Louisiana Coastal Protection and Restoration

Fish and Wildlife Service Planning Aid Report

Plan Formulation Planning Aid Report

**Provided to
New Orleans District/Vicksburg District
U.S. Army Corps of Engineers**

Figure 1. Potential Lake Pontchartrain Basin hurricane protection levee alignments.

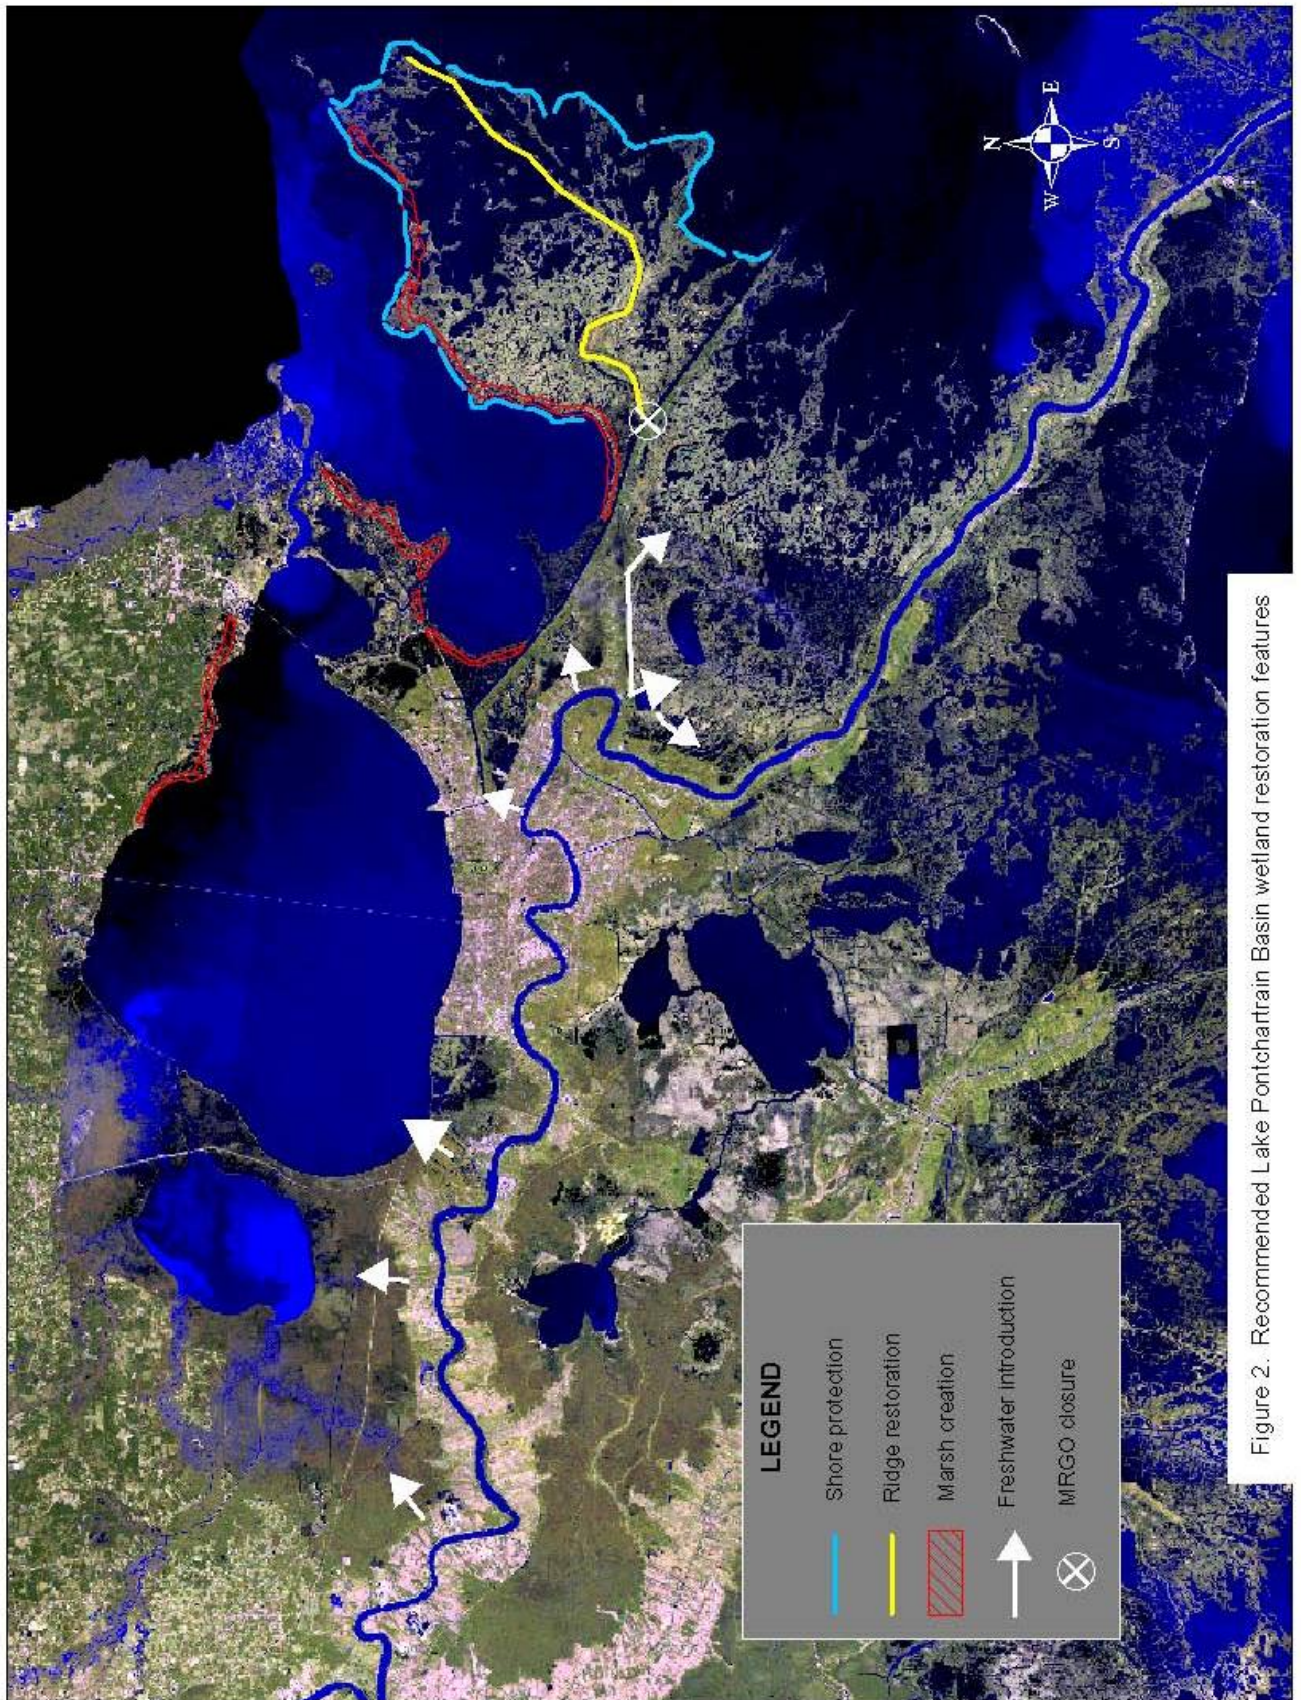
The proposed enclosure of Lake Pontchartrain could impact the drainage of excess precipitation, restrict operation of the Bonnet Carre Spillway, and reduce ingress and egress of estuarine-dependent fishes and shellfishes. Construction of a storm surge barrier across the Lake Borgne landbridge would also result in substantial construction-related marsh losses. Based on the experience of storm-related debris obstructing such structures, the threat of impaired post-storm drainage must also be taken into account. A possible alternative to avoid those enclosure-related adverse impacts would consist of a multiple lines of defense approach, coupled with improving existing levees around New Orleans, constructing the proposed West Shore Lake Pontchartrain features, and constructing new lake-front levees for Slidell and other communities along the north shore of Lake Pontchartrain (Figure 1). A major levee around eastern New Orleans could be afforded greater protection from open waters of Lake Borgne if it were located along or west of the existing Maxent Canal levee rather than along the existing outermost levee. Such new levees should be constructed on non-wetlands to the greatest degree possible.

If that alternative is not as feasible, or would result in greater construction-related wetland losses than the proposed Barrier Plan levee across the Lake Borgne landbridge, the proposed barrier plan structures in the Rigolettes and Chef Menteur Passes should be sized to avoid any reduction in the existing cross-sections of those passes. Restoration and protection of natural protection features, located primarily in the Biloxi marshes, should also be included in that plan to provide additional seaward defenses.

To reduce construction-related wetland impacts in the Lake Borgne area, the protection levee should be located on the north bank of the Gulf Intracoastal Waterway (GIWW) and on Mississippi River Gulf Outlet (MRGO) spoil banks. This approach would require only one major structure in the GIWW rather than two (i.e., in the GIWW and MRGO). Compared to locating the levee along the western shore of Lake Borgne, the marshes seaward of the Service's alternative would help protect that levee and would reduce direct exposure of that levee to surge and waves in Lake Borgne.

The proposed construction of the protection levee up the western edge of the Pearl River basin would likely result in intercepted drainage and ponding of excess water within enclosed bottomland hardwoods. Those indirect adverse impacts could be avoided by constructing an interior collection canal emptying into the Fritchie Marsh. Although the Fritchie marshes could potentially benefit from the resulting additional freshwater inputs, northward saltwater intrusion into enclosed cypress swamps and bottomland hardwoods would have to be avoided. Those issues cannot be addressed or resolved until a detailed levee route is identified.

Figure 2. Recommended Lake Pontchartrain Basin wetland restoration features

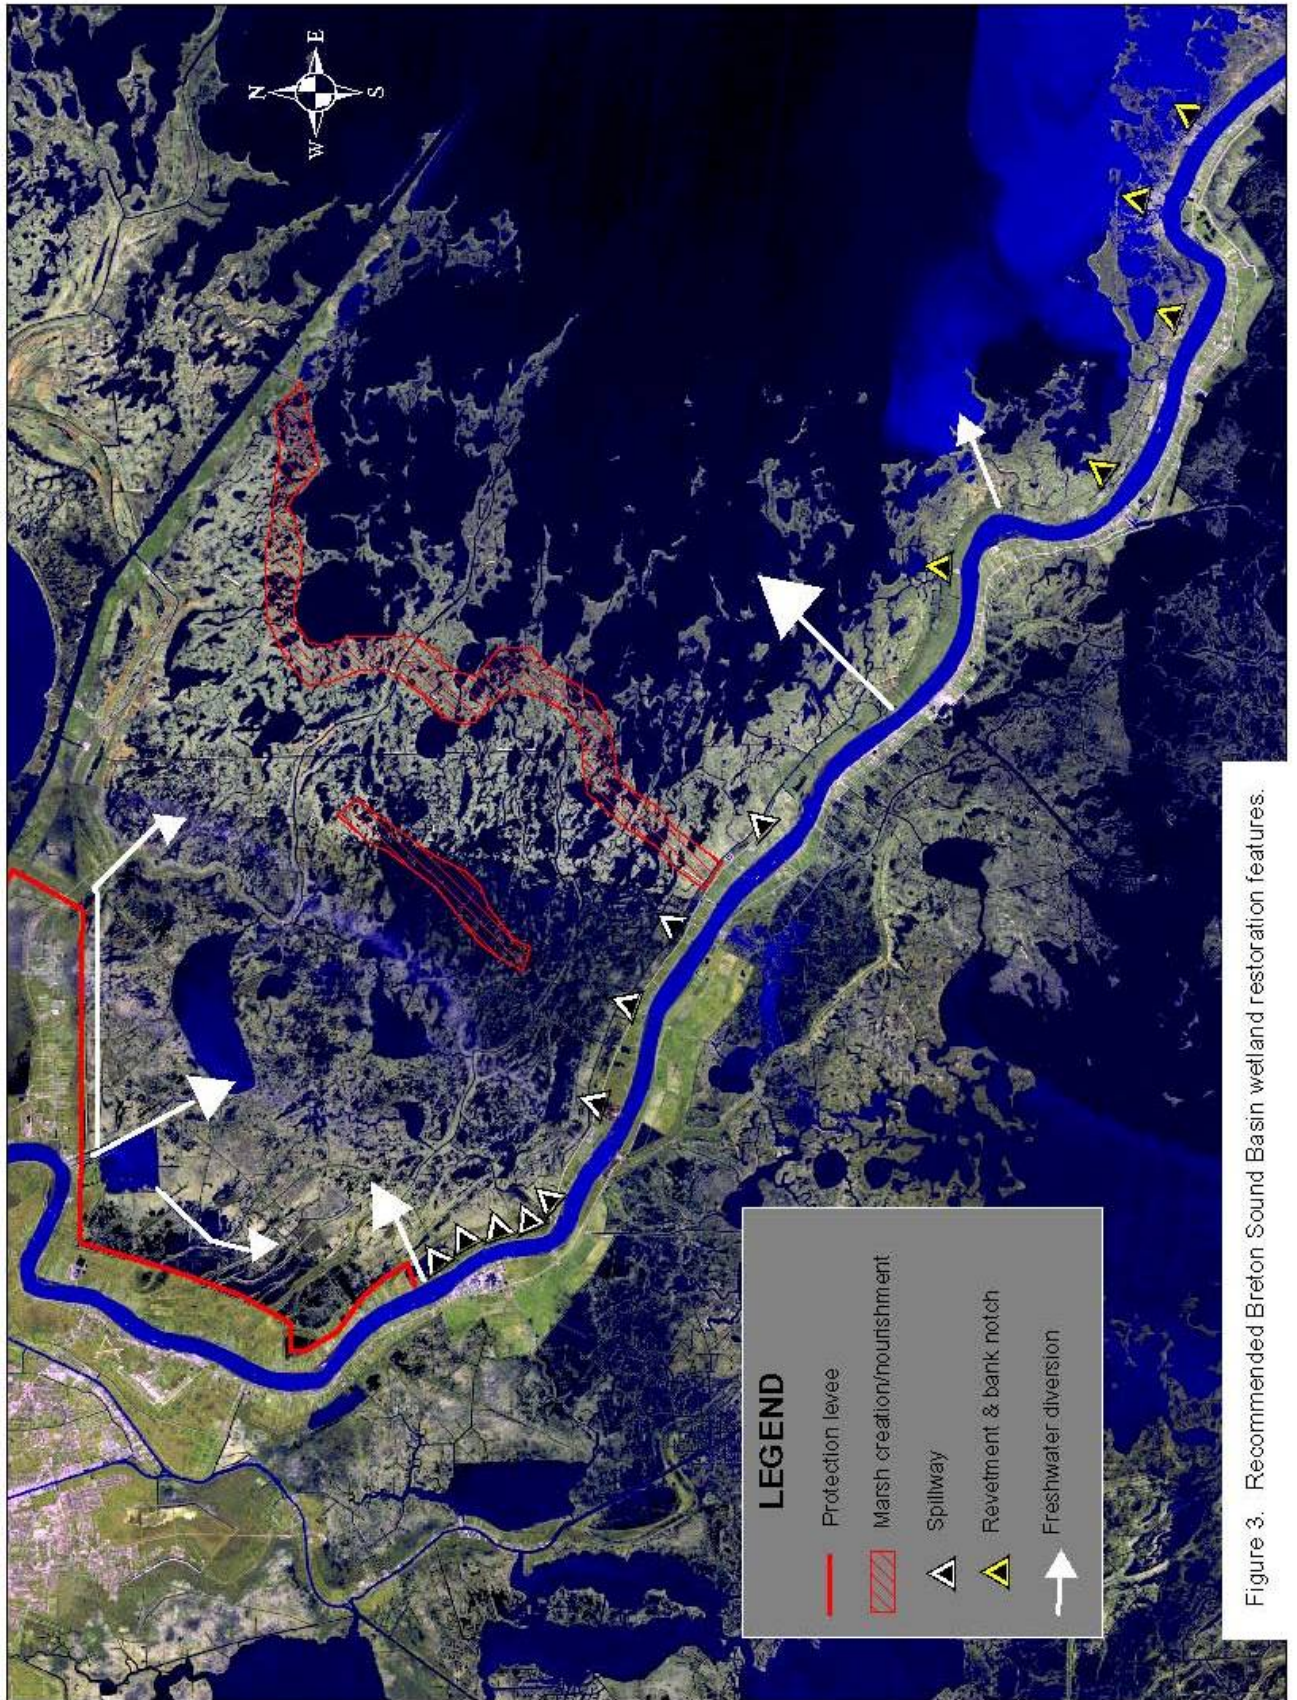
Long-term marsh vigor and nourishment for those marshes should also be provided by implementing strategic Mississippi River diversions. Enlargement of the existing Violet Siphon and/or diversions through the Inner Harbor Navigation Canal Locks would help achieve this goal, provided that the MRGO is closed or significantly constricted. Otherwise, the opportunistic use of the Bonnet Carre Spillway could potentially help achieve this need. Diversion-related algal blooms in Lake Pontchartrain could be reduced or avoided if that spillway is modified to reduce channelized flows and increase overland flows. If diversions would maintain suitable salinity ranges in the outer Biloxi marshes for optimal oyster production, then efforts to protect that area could be enhanced by establishing segmented oyster reefs around the Biloxi marsh complex. Specific restoration measures listed below are identified as either providing immediate storm surge protection benefits (I), or long-term, sustainable protection (S).

1. Create/nourish marsh along the southeastern fringe of the Lake Borgne landbridge to restore and maintain its integrity. Construct erosion protection features and conduct periodic marsh creation/nourishment where and as needed. (I)

2. Create an elevated and armored rim along the western shore of Lake Borne to prevent future shoreline erosion and reduce inland propagation of storm surges and waves into that area. That feature would consist of a higher forested lake rim sloping downward to a broad interior marsh platform. (I)

3. Elevate and widen the intact portion of the Bayou LaLoutre ridge, rebuild the largely eroded northeasternmost portion and reforest it. Rebuilt portions of the ridge would include broad marsh aprons on either side. (I)

4. Rebuild the eroding Biloxi marsh rim along the south shore of Mississippi Sound. (I)
5. Protect existing and restored features within the Biloxi marshes by constructing erosion protection features around the exposed perimeter of that marsh complex. (I)

6. Close and restore the Mississippi River Gulf Outlet to protect and sustain natural protection features, and rebuild such features where necessary. (S)

7. Nourish and sustain Biloxi marshes and Lake Borgne landbridge marshes with seasonal introductions of Mississippi River water by enlarging the existing Violet Siphon or by diverting water through the Inner Harbor Navigation Canal Locks. This goal could be achieved provided that the MRGO is closed or significantly constricted. Otherwise, the opportunistic use of the Bonnet Carre Spillway may help achieve this need. (S)

Figure 3. Recommended Breton Sound Basin wetland restoration features.

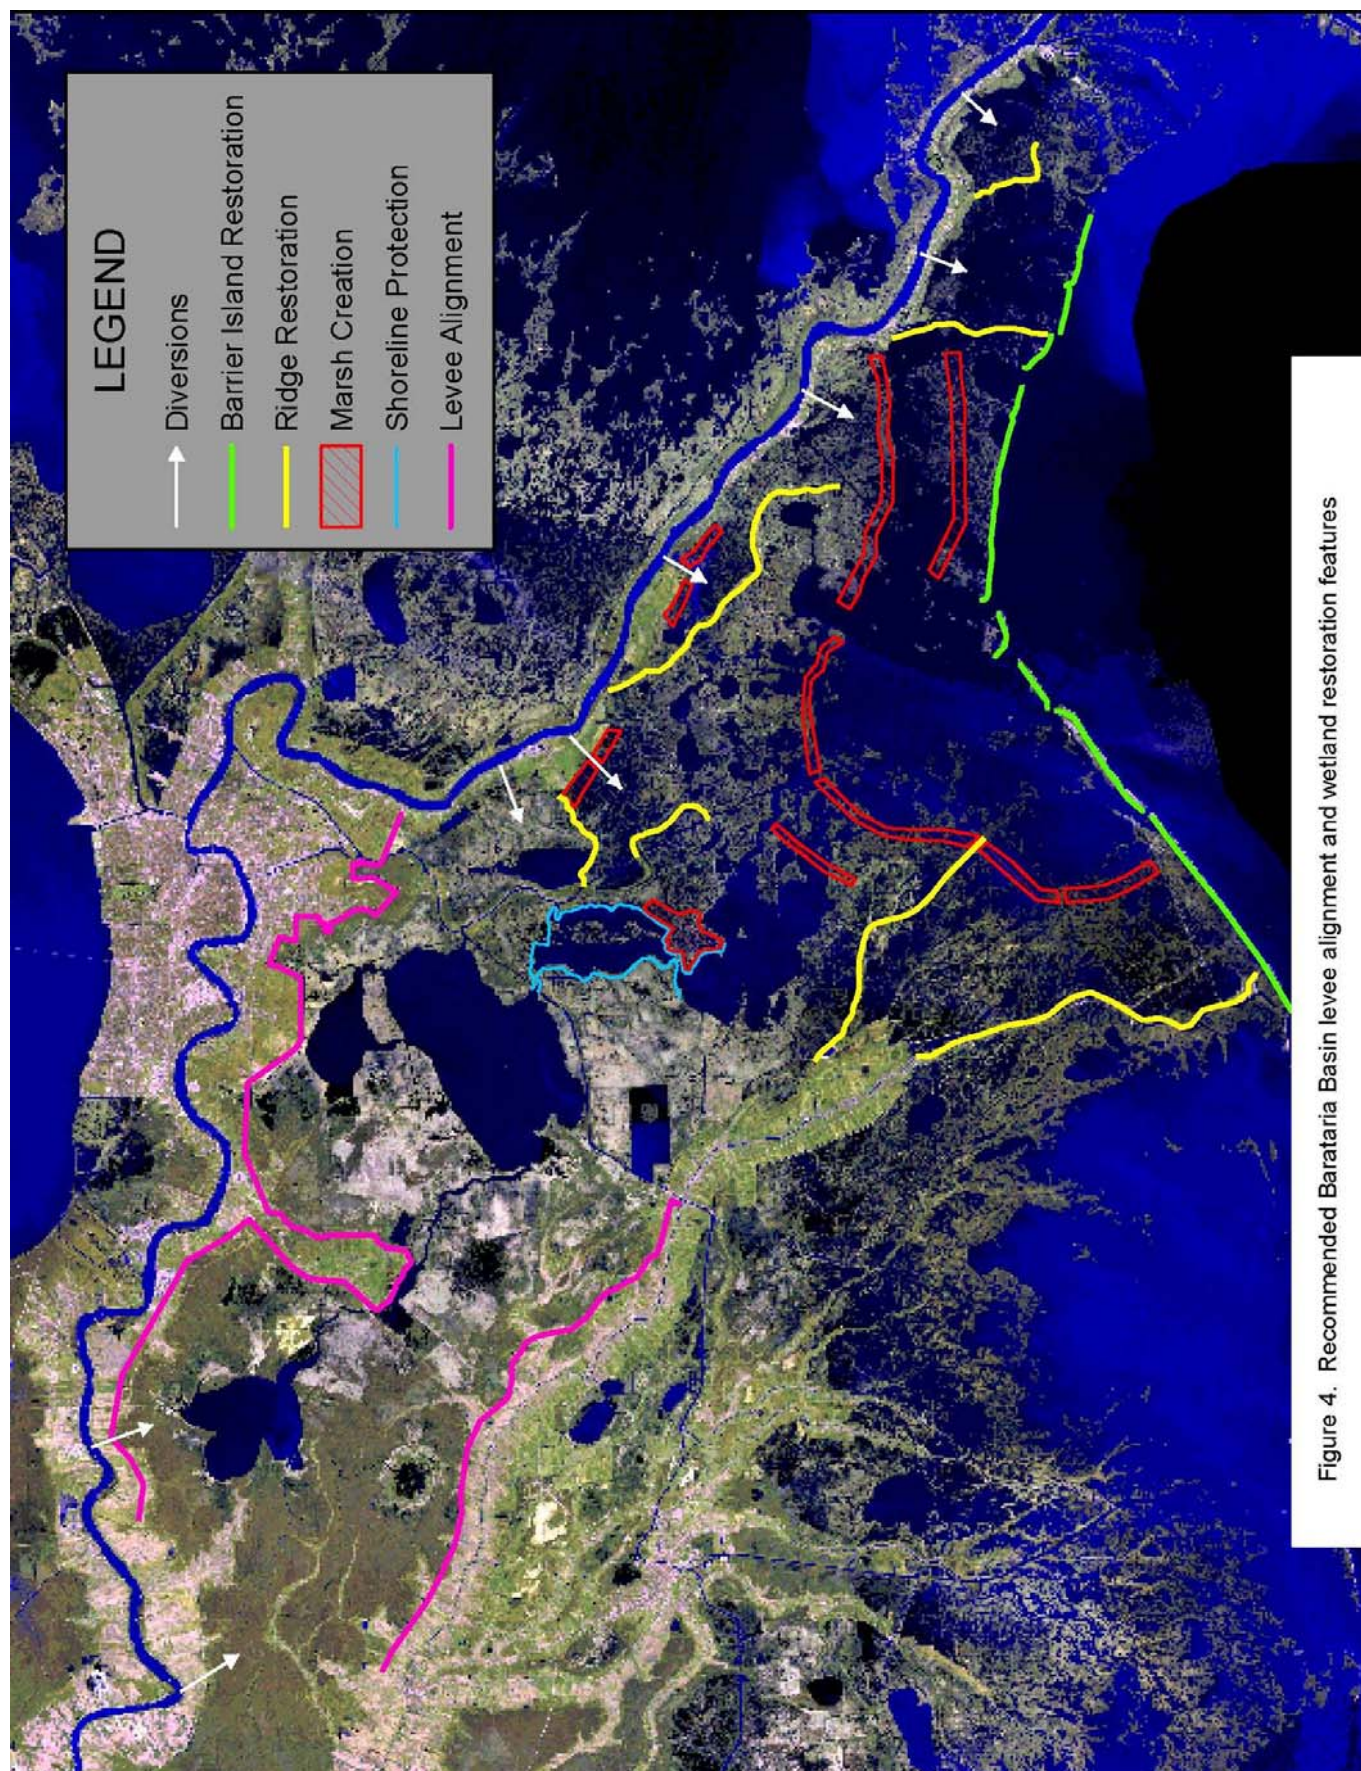
The Service recommends the construction and operation of Mississippi River diversions and overflow spillways to rebuild and nourish marsh sufficient to achieve long-term net wetland gains and provide storm surge buffering (Figure 3). Spillway elevations should be capable of conveying river water during all but low water periods. More immediate storm surge protection should be provided by constructing a band of marsh across the mouth of the basin at the heads of the bays. That band should also include an elevated bay rim and armoring or other means of erosion protection as warranted by site-specific conditions. Construction and operation of a major land-building diversion at American Bay would deposit sediments in local lakes and bays that would be reworked on to the bay-edge marshes, thereby reducing wind-wave related erosion, and providing long-term protection of marshes in the southern portion of the basin. Along the Mississippi River below Pointe-a-la-Hache, a series of revetment and bank notches should be constructed to allow sediment inputs to sustain and increase the adjacent wetlands and offset erosion-related wetland losses of those marshes exposed to Breton Sound and other large open water bodies. Specific restoration measures listed below are identified as either providing immediate storm surge protection benefits (I), or long-term, sustainable protection (S).

1. Construct a major land-building diversion at American Bay. Adaptively manage the outfall area to maximize deltaic land-building. (S)
2. Construct a sediment diversion (e.g., (15,000 to 20,000 cfs) at White's Ditch to build and nourish existing marshes in the southwest and central portions of the basin. Adaptively manage the outfall area to maximize distribution of introduced water and suspended sediment. (S)

3. Where no back protection levee exists below Bertrandville, degrade the existing Mississippi River levee crest sufficiently to create a spillway. If needed, maximum crest elevations within that spillway should be lowered and appropriately armored to facilitate annual discharges during all but low water periods to sustain basin wetlands and repair Hurricane Katrina-related wetland impacts. (S)

4. Operate the Caernarvon Diversion to maximize land-building and wetland maintenance processes. (S)
5. Direct Caernarvon Diversion flows eastward into the subbasin north of the Bayou Terre aux Boeufs ridge by constructing a continuous borrow canal (associated with levee construction) along the foot of the existing protection levee from Caernarvon to and across the Bayou Terre aux Boeufs ridge. (S)

6. Increase Caernarvon Diversion flows southwestward by enlarging an existing canal on the southwest corner of the Big Mar. (S)
7. Construct 3 or 4 small Mississippi River spillways (approximately 1,300 to 3,000 feet wide) through the protected corridor between Carlisle and Bohemia to nourish existing marsh and rebuild eroded marshes. If needed, maximum crest elevations within those spillways should be lowered and armored as needed to facilitate annual overflow during all but low river stages.
